ADDENDUM NUMBER TWO (2)

Project: Construct ACFT Overhead Cover (PN: 28190207)  
Add/Alt to S271 Latrine (PN: 28200218)  
Camp McCain Training Center  
Grenada, MS  
PN: 19058 & 19080

FROM: Dean and Dean/Associates Architects, P.A.  
4400 Old Canton Road, Suite 200  
Jackson, MS 39211  
(601) 939-7717

### OVEREXCAVATION AND BACKFILL DETAIL

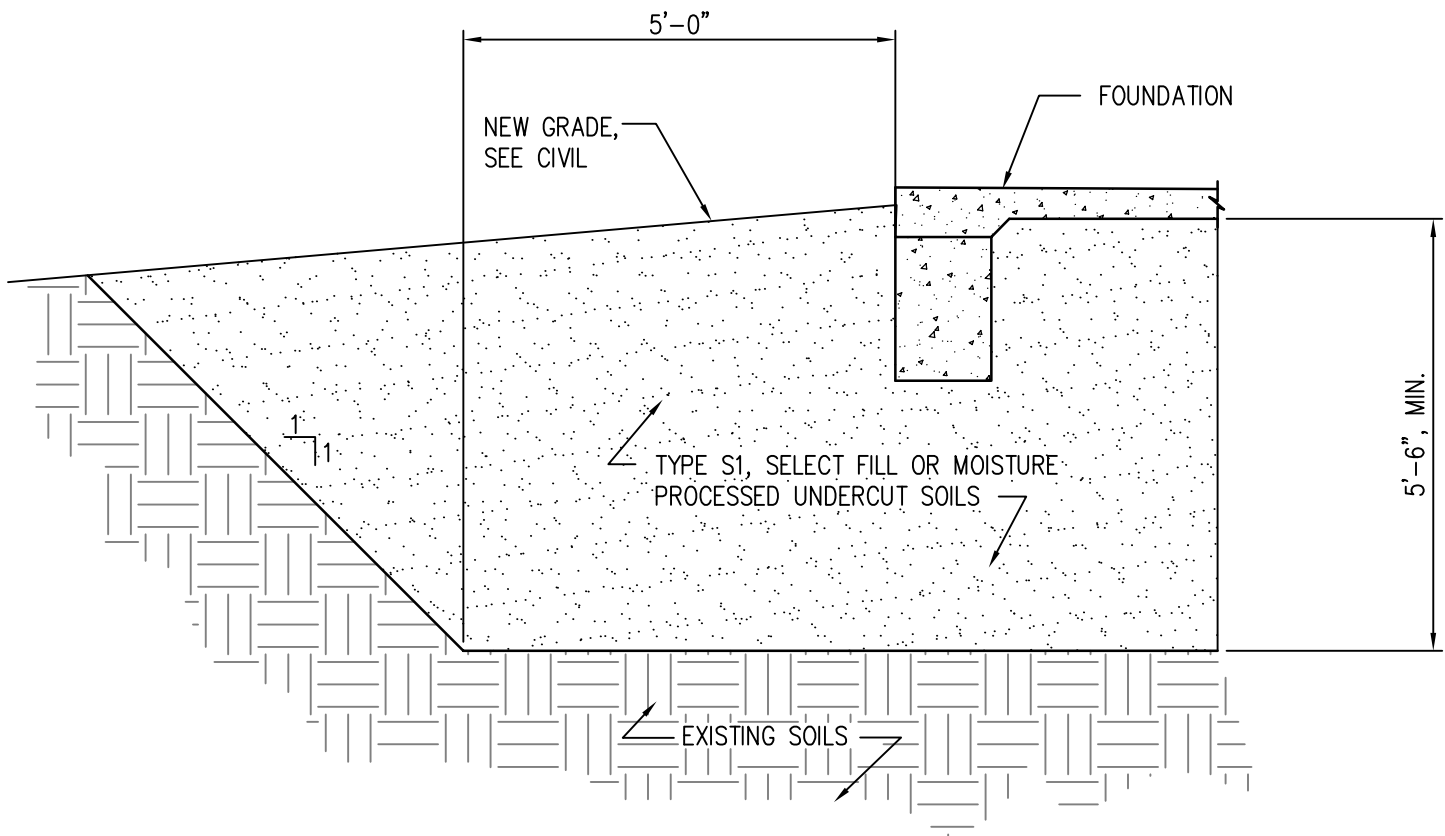
See the attached sketch for the requirements for undercut and backfill below the building.

1. THE CONTRACTOR SHALL OVEREXCAVATE AND BACKFILL UNDERNEATH THE BUILDING PER THE ABOVE DETAIL.
2. CONTRACTOR SHALL VERIFY THE EXISTING SOILS AT THE BOTTOM OF THE EXCAVATION ARE STIFF AND STABLE BEFORE BACKFILLING BEGINS.
3. UNDERCUT SOILS ARE SUITABLE TO USE AS STRUCTURAL FILL, BUT WILL REQUIRE MOISTURE CONDITIONING TO MEET THE REQUIREMENTS OF STRUCTURAL FILL. IF REQUIRED STRUCTURAL IMPORTED FILL MATERIAL IS NECESSARY, SEE SPECIFICATIONS FOR ALLOWABLE TYPE S1 FILL. INSTALL PER SPECIFICATIONS.
4. PROVIDE TESTING OF ALL EXISTING SOILS AND FILLED SOILS AS REQUIRED IN THE SPECIFICATIONS.
